## ALERT SERVICE BULLETIN

**206-20-139**

Revision A, 21 August 2020

**SUBJECT:** SEGMENTED TAIL ROTOR DRIVESHAFTS 206-040-330-003/-101, 206-040-931-009/-011/-101/-103, 206-040-365-101/-105/-121/-123 WITH BONDED ADAPTERS, PROOF LOAD TEST OF.

Figure 1 – Bonded Shaft Tool (206-244-001-101)

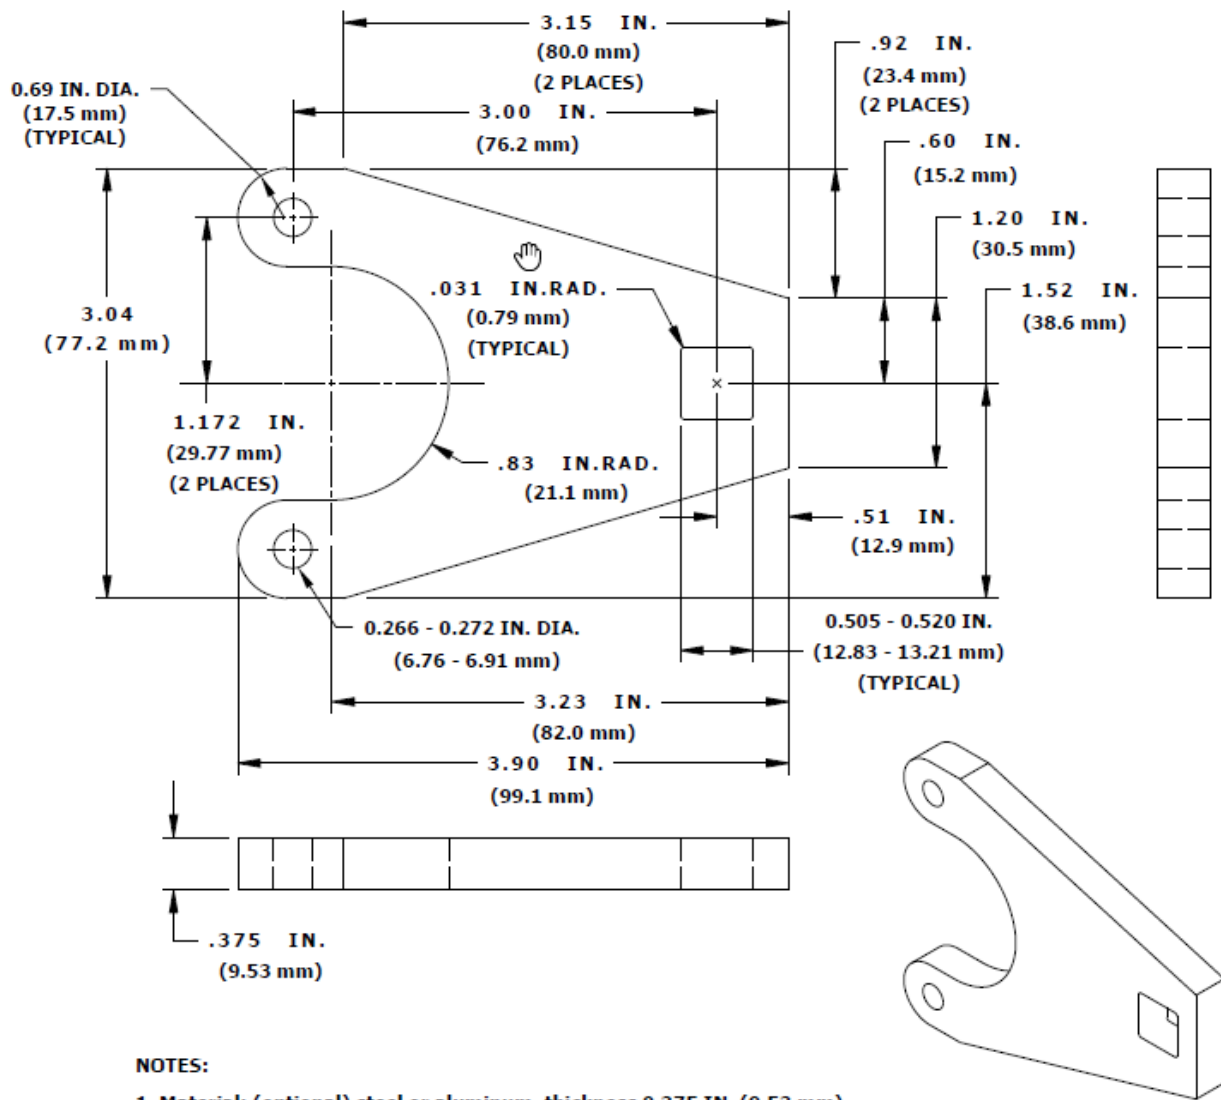
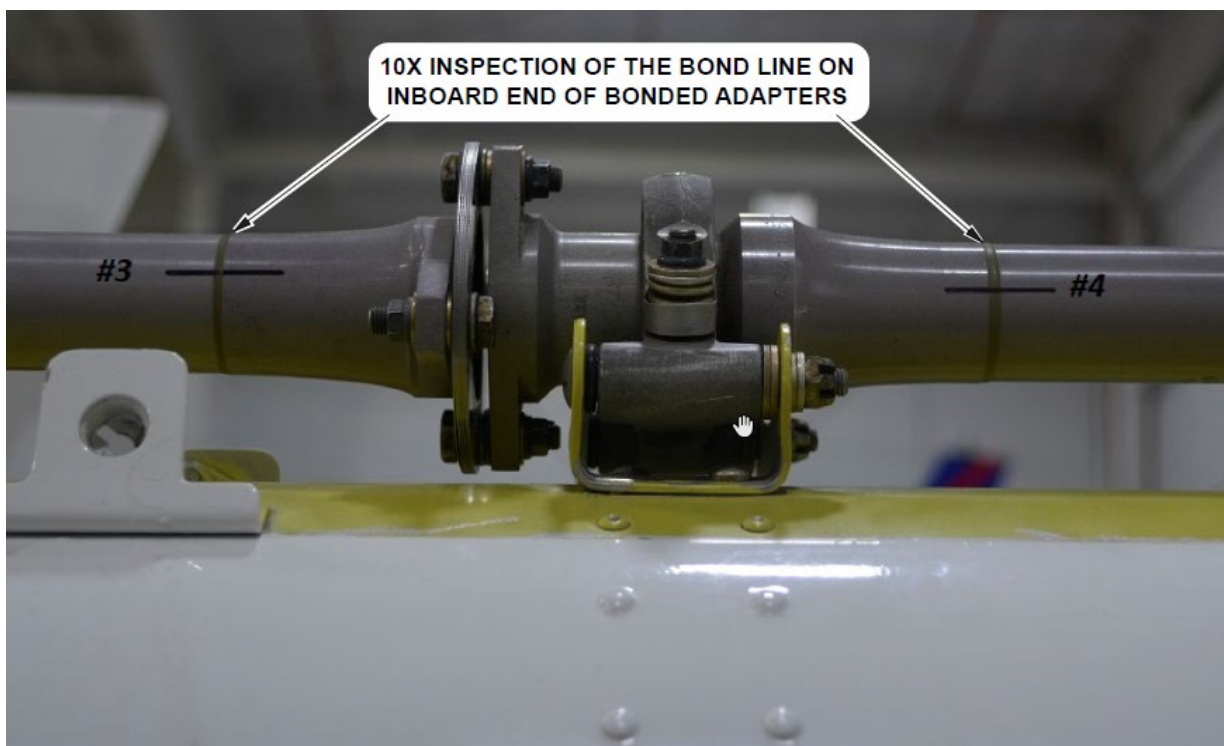
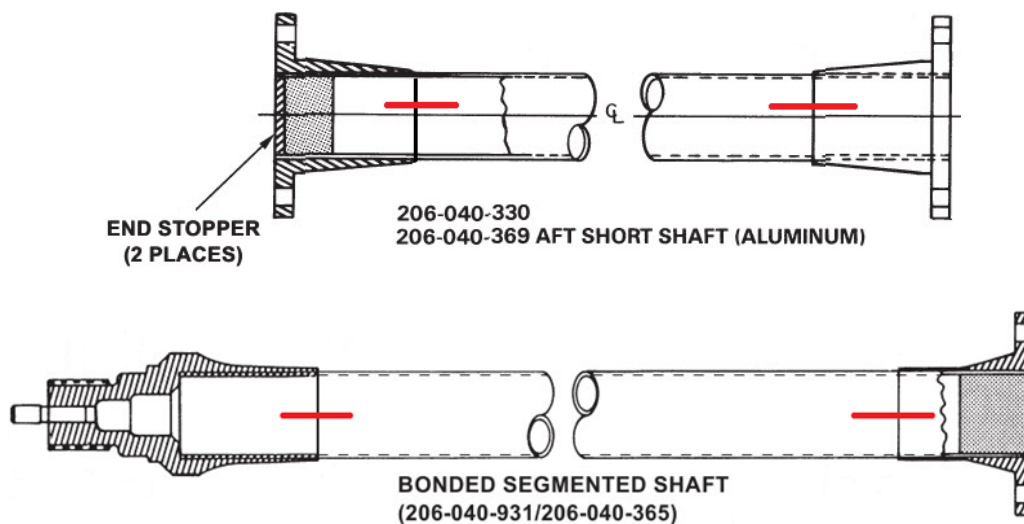
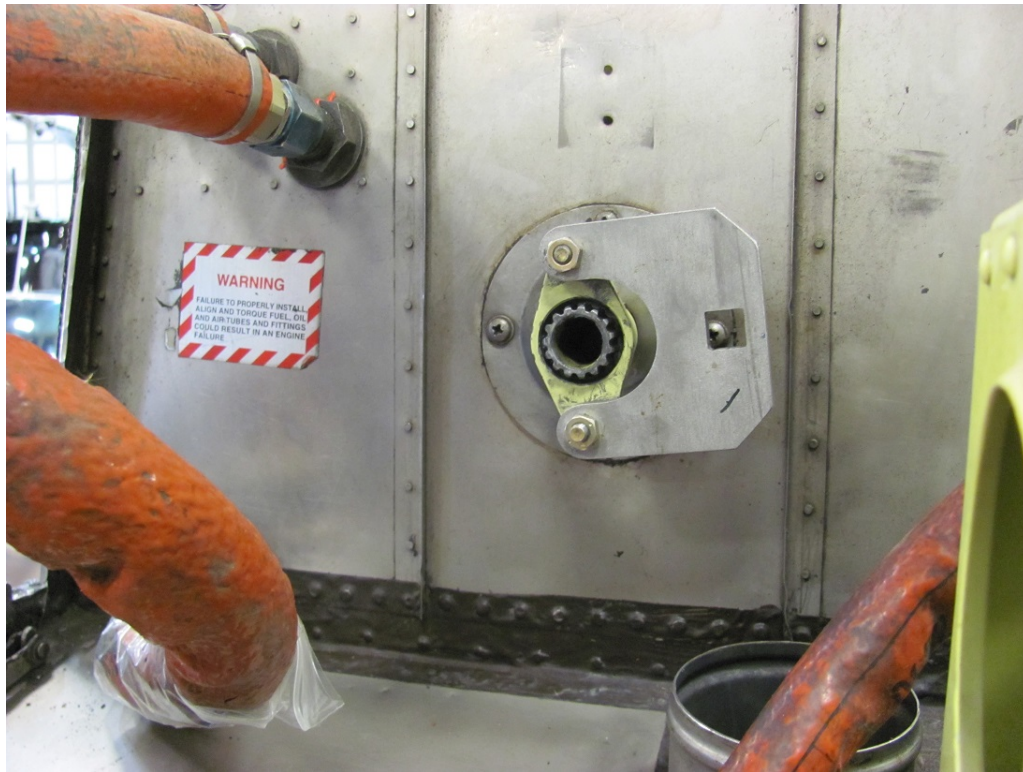
**Revision A** allows failed bonded tail rotor driveshafts to be replaced with serviceable bonded driveshafts that meet the intent of this bulletin and makes corrections to some of the metric dimensions in Figure 1 of this bulletin. It is also being used to inform owners and operators that some helicopters outside of the **HELICOPTERS AFFECTED** serial number range may have been modified with segmented bonded shafts through local aviation authority approvals; in this case, the bulletin shall be carried out on those helicopters as well.
